ROSA Inc.
Ramapo Organized for Sustainability and a Safe Aquifer
PO Box 712
Pomona, NY 10970

January 7, 2013

RE: Comments regarding Patrick Farm NYS DEC Applications

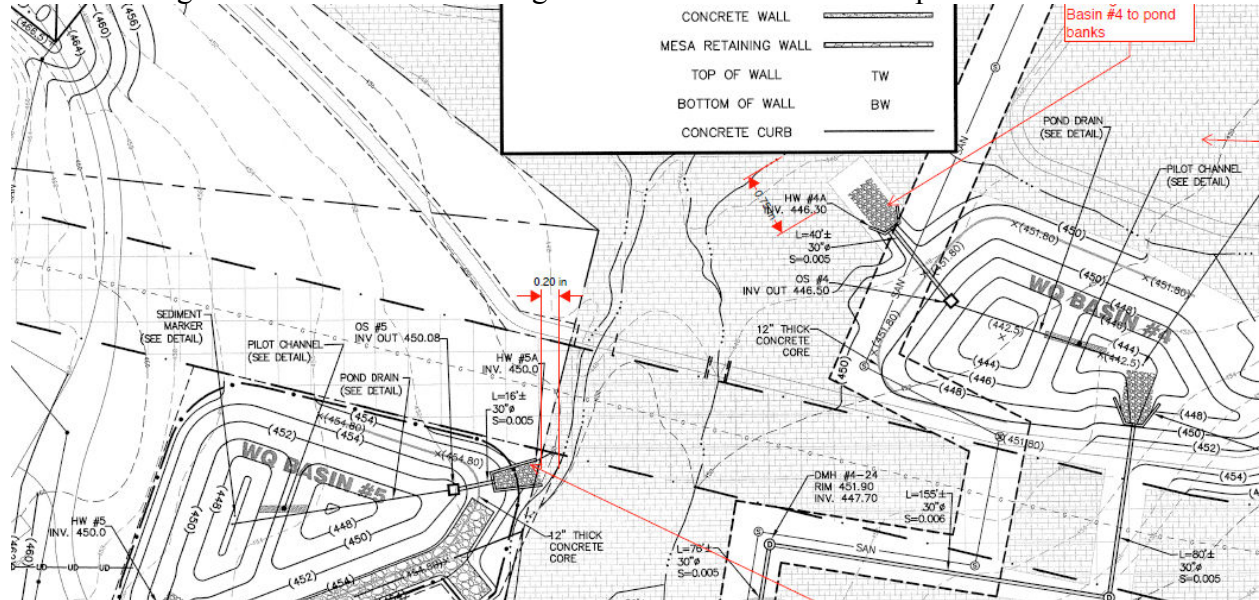
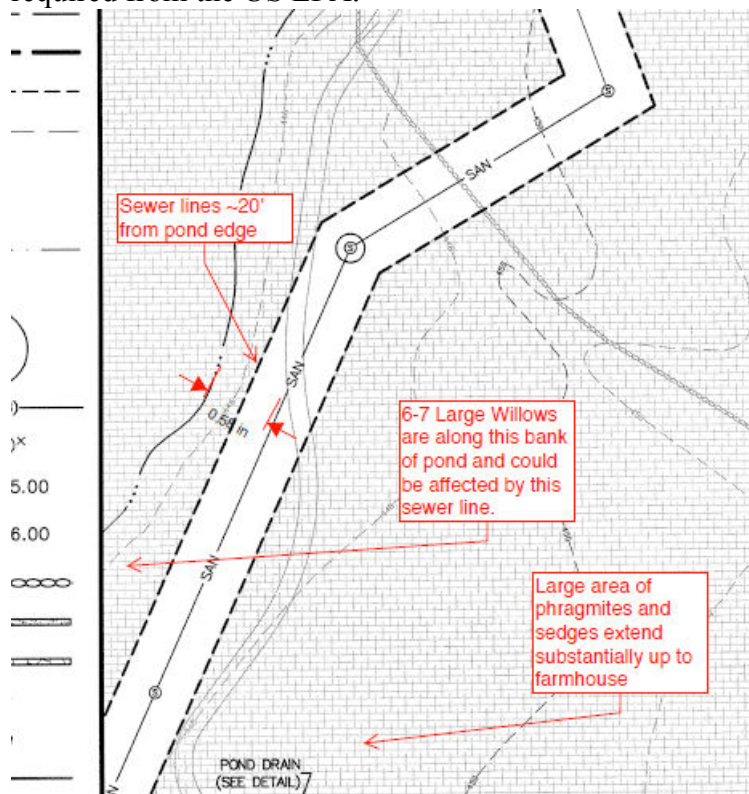
Water Quality Basin #4 drains to wetland around pond <50' from pond edge; note obscured by legend on drawing and Water Quality Basin #5 drains to tributary <10

Directly above this area shown on drawing #18 you can see the sewer line crossing through the banks of the pond within 20' of the pond edge where there are willow trees and phragmites growing. **NOTE: If ACOE confirms this as a Wetland area then a new ESA Waiver will be required from the US EPA.

Water Quality Basin #6 and #7 Drains into ACOE A (Drawing #13 of subdivision)

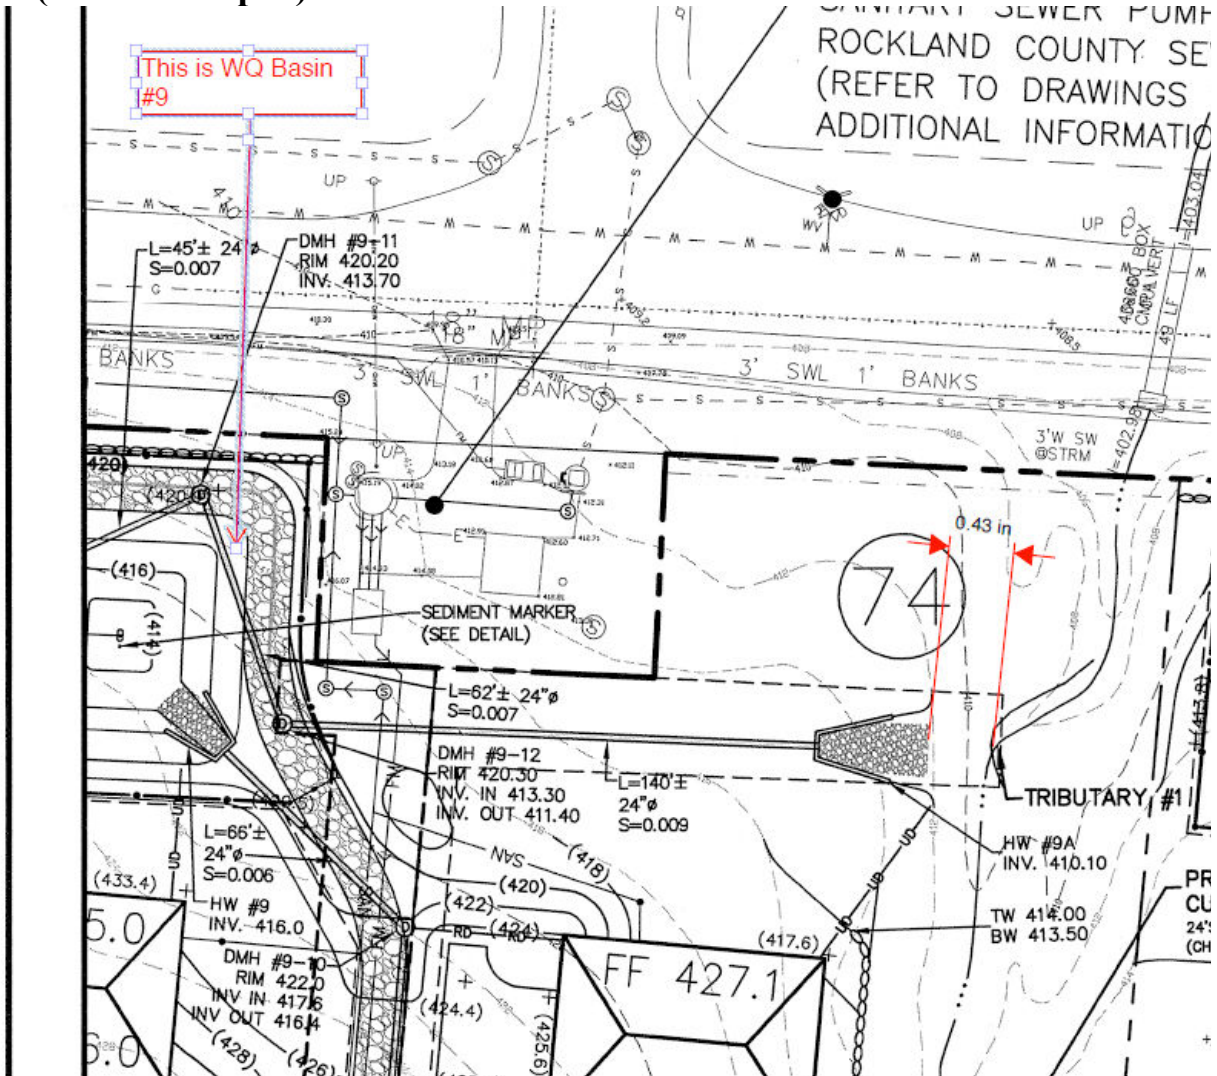
Taking roof drainage and routing it away from wetlands will starve wetlands.

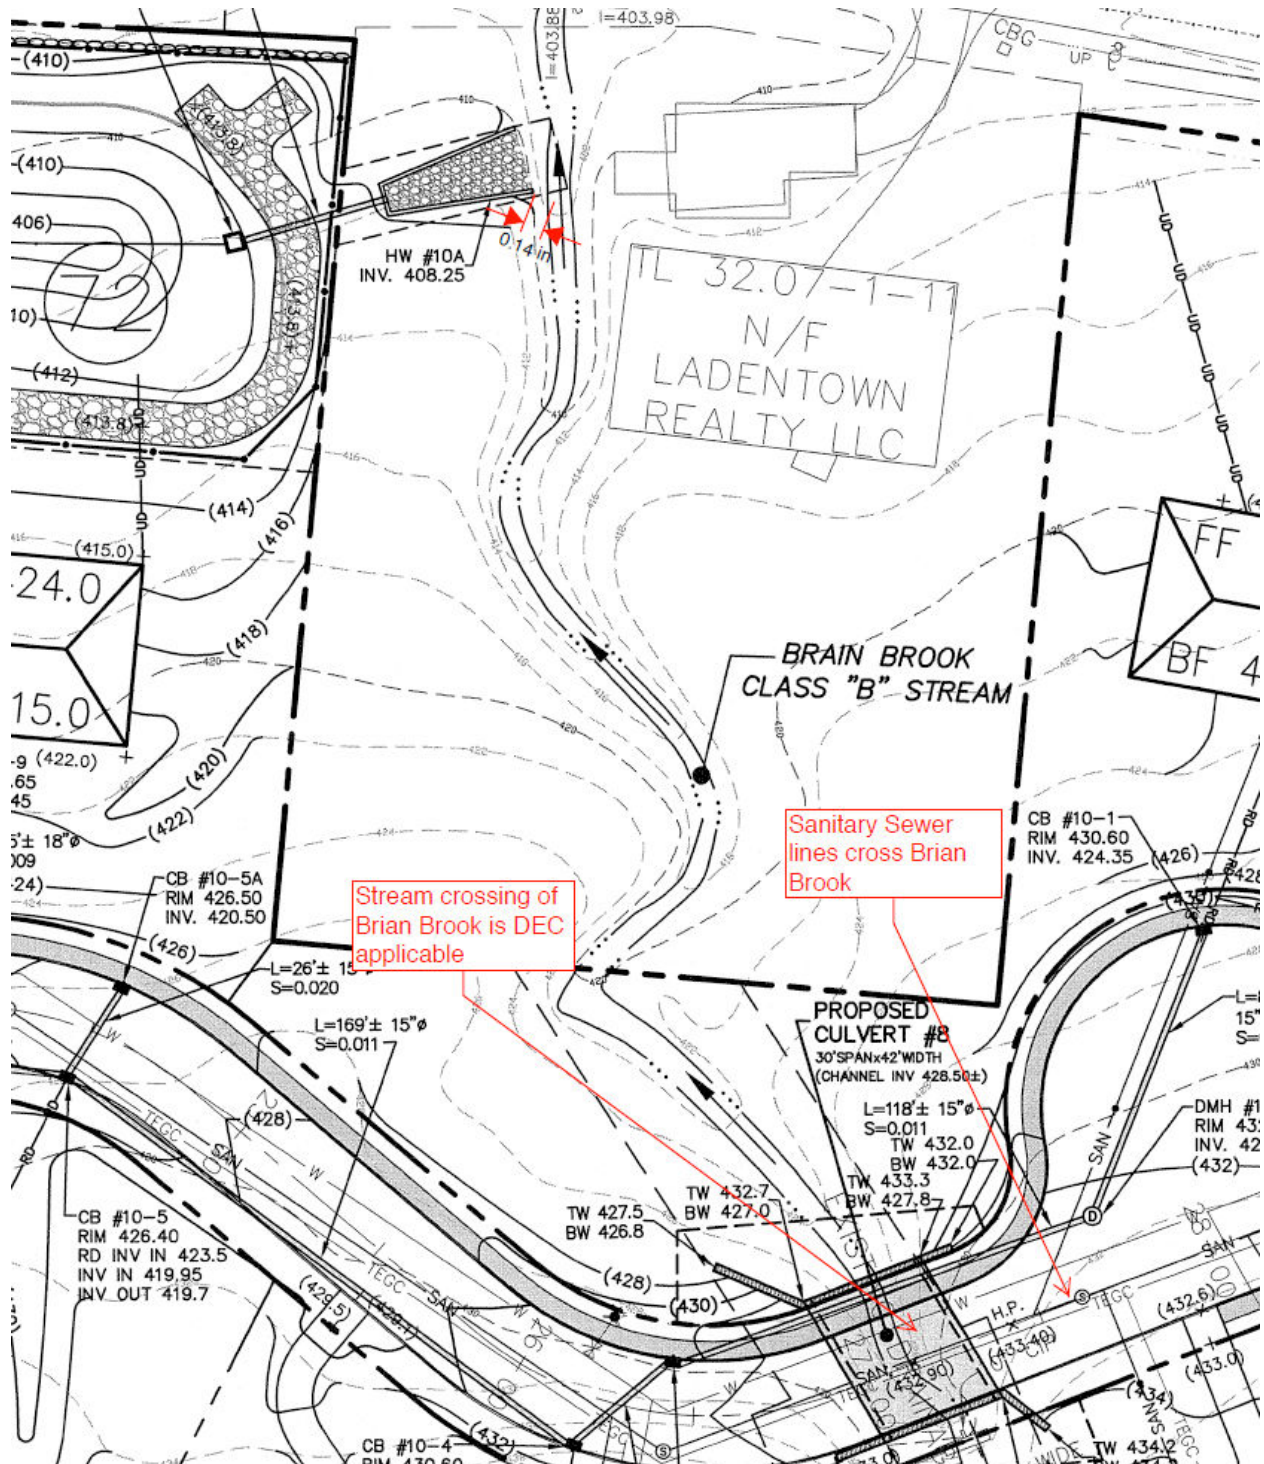
Water Quality Basin #9 drain to unnamed tributary #1 to Mahwah River <20' (subdivision p16)

Water Quality Basin #10 shown on subdivision p16 drains to class B Brian Brook off site. ~10' (subdivision p16)

The following extract from final subdivision drawing #16 shows the culvert over the Class B Stream Brian Brook, a sanitary line crossing the stream and the outflow from WQ Basin #10

Walkway South and South East of Pond

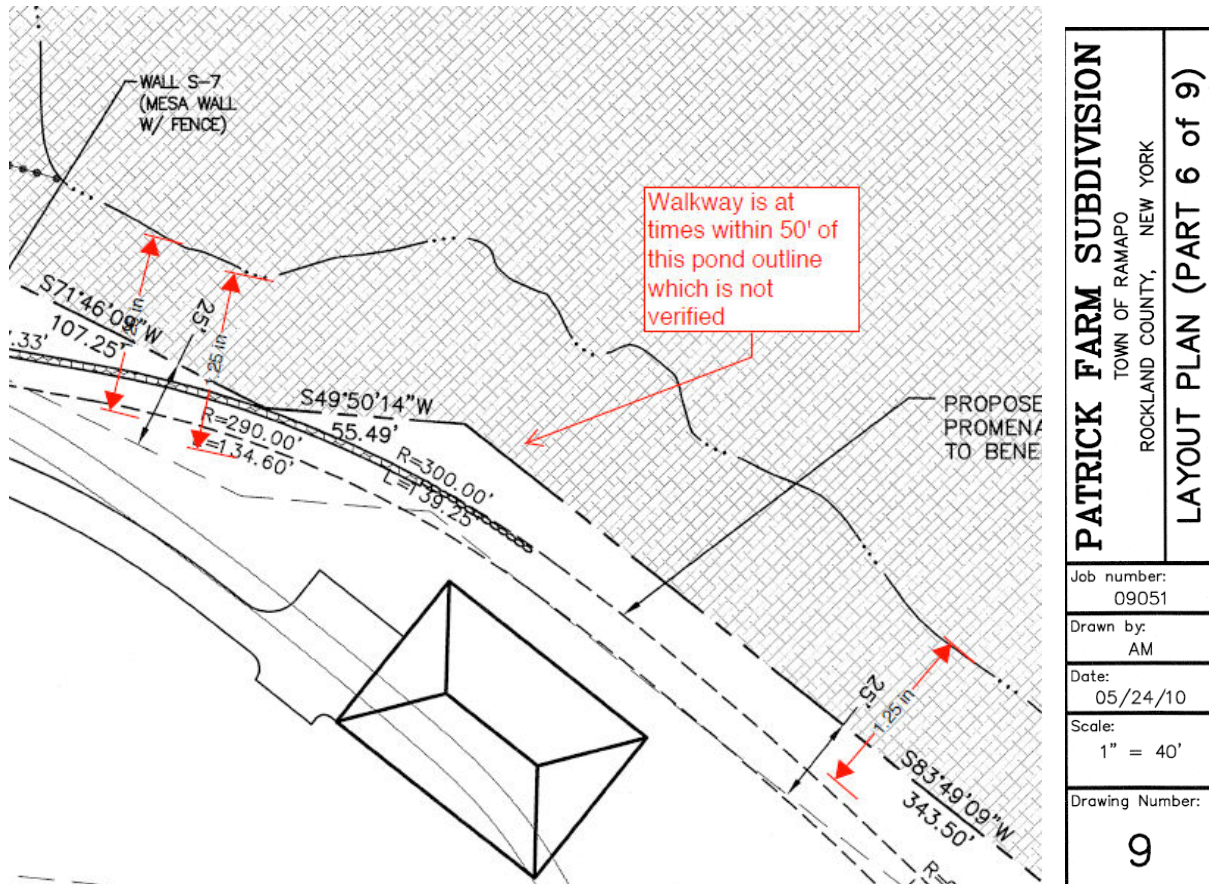
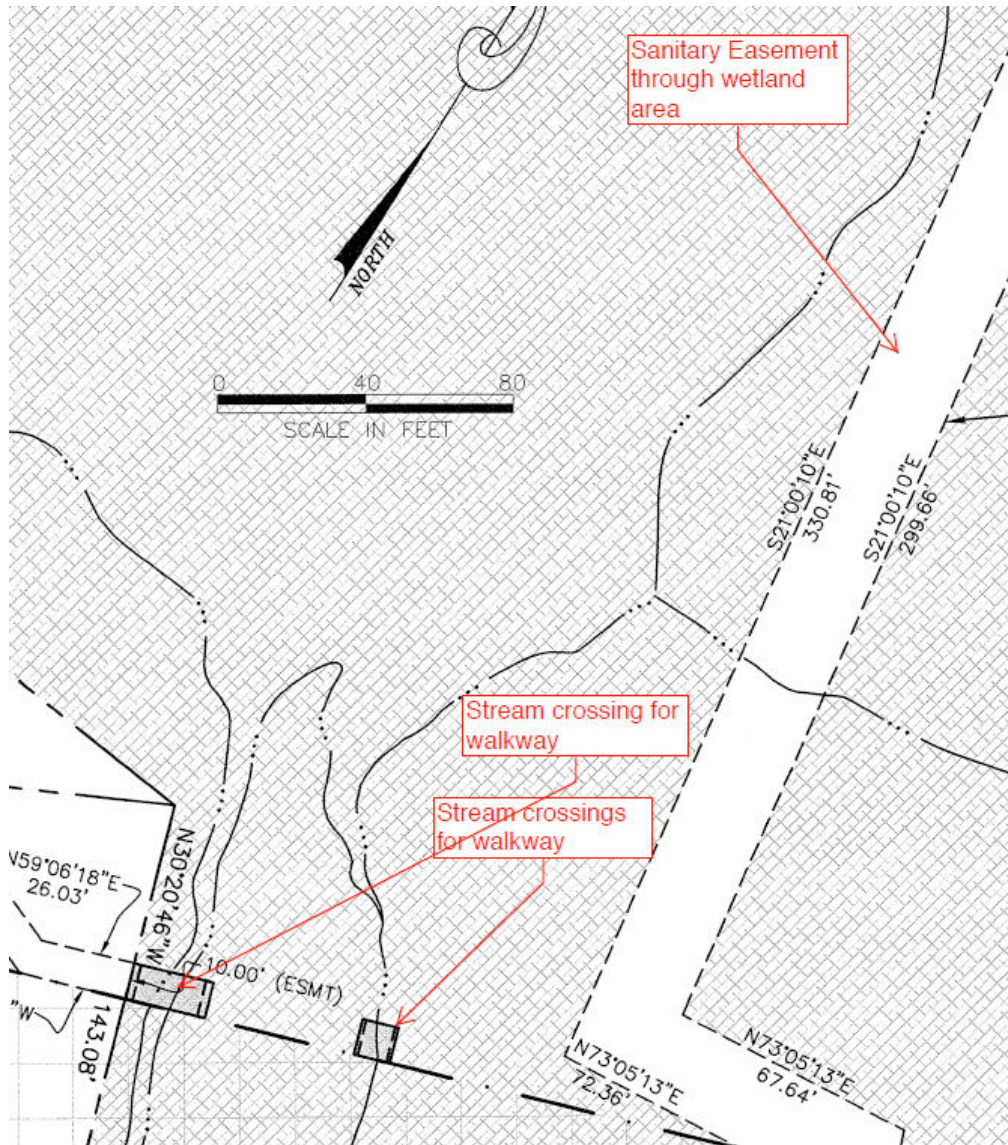
The area where the applicant proposes a walkway is a key area of dispute regarding wetlands and boundaries. It was noted by DEC in its letter of 2009-12-30, which discusses potential streambed disturbances. The applicant was supposed to justify its necessity. It appears that this walkway and the stream crossing might be under water caused by raising the dam. Certainly it will require fill in the wetland area adjacent to the WOUS.

Also from subdivision drawing #9 you can see that the walkway crosses over two tributaries to the stream in a sensitive wetland area. These crossings are not highlighted. And you can also see the sanitary easement for the sewer lines that are crossing directly through the path of the willows trees that border the east/southeast section of the pond.

Fill Northwest of Pond for buildings 127 + 88 on extremely steep slope

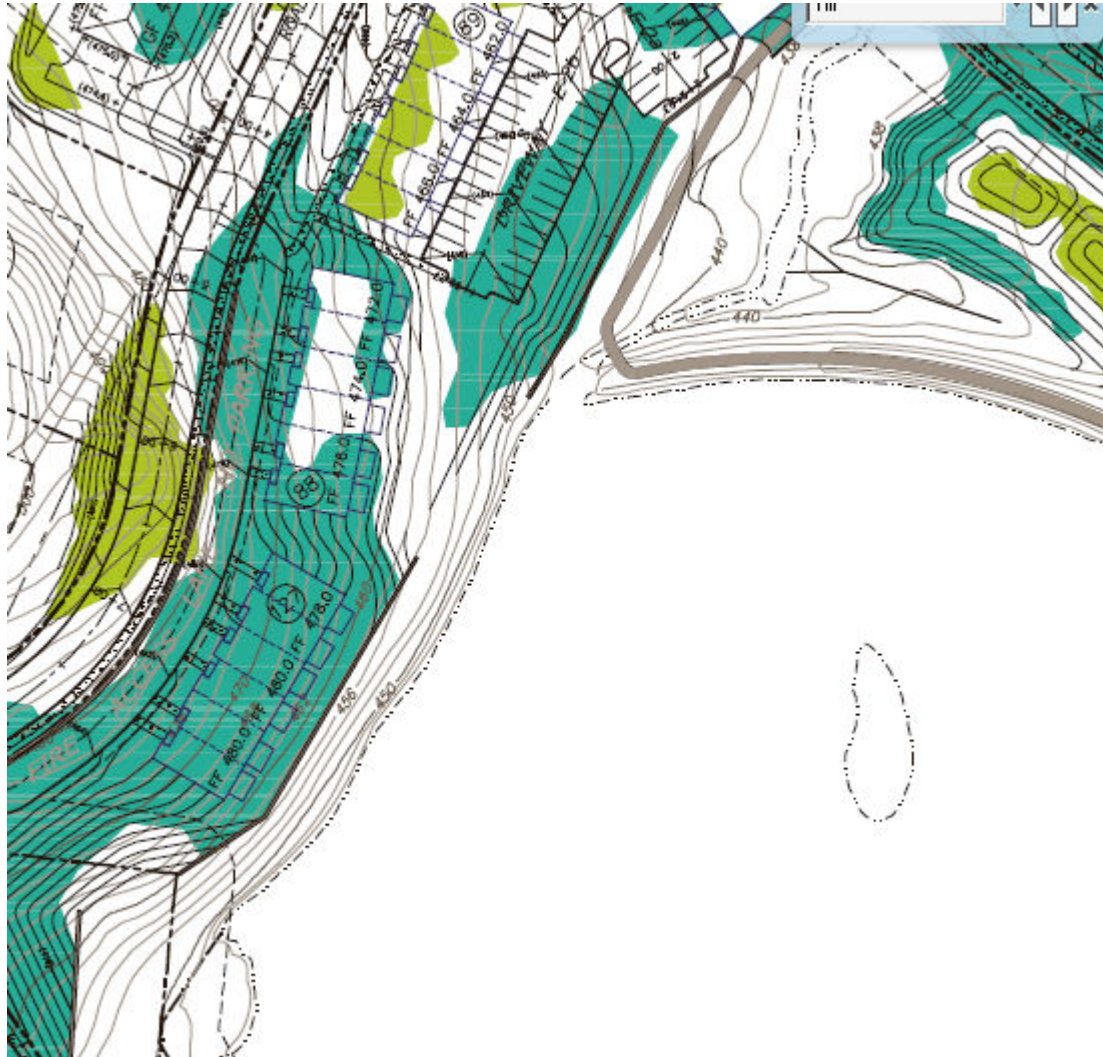
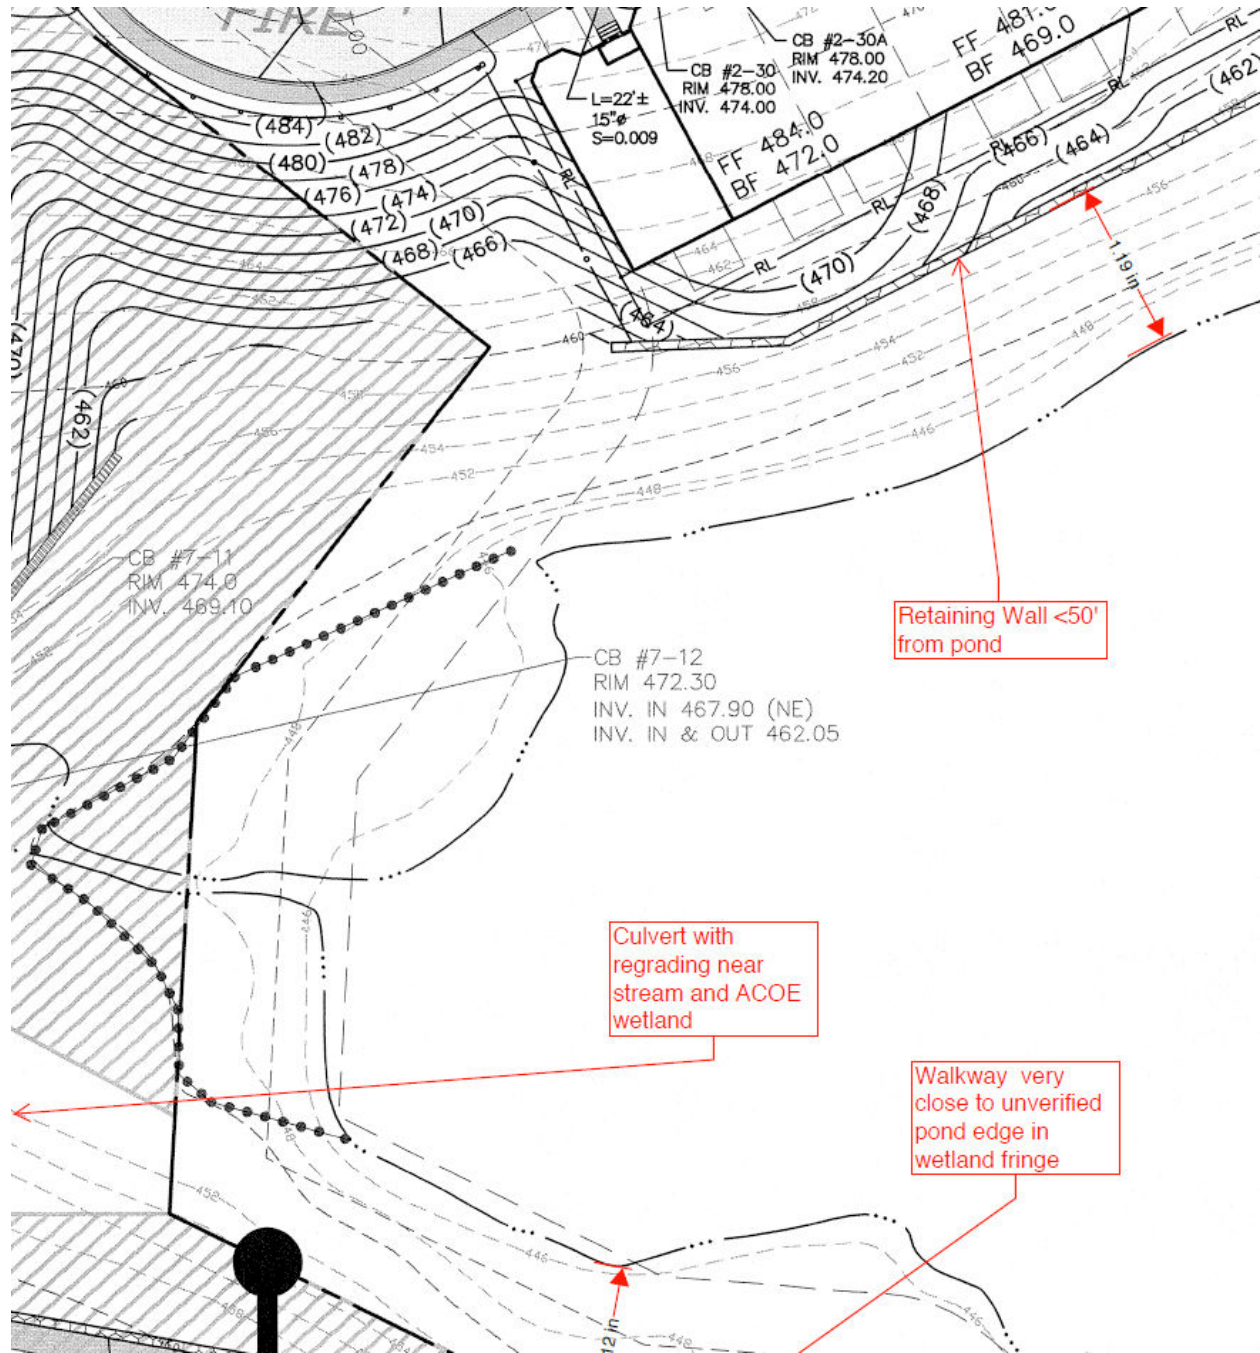
The following excerpt from the cut and fill Figure 3.1-7 of the DEIS shows plans to fill the steep slope north of the pond and build a retaining wall. With the new Dam Ordinary High Water Mark this distance will be even closer.

The following is from Figure 7 of the Final Site Plan for the Condominiums and shows that this retaining wall is <50' from the pond edge. With the new Dam OWHM this distance will be even closer.
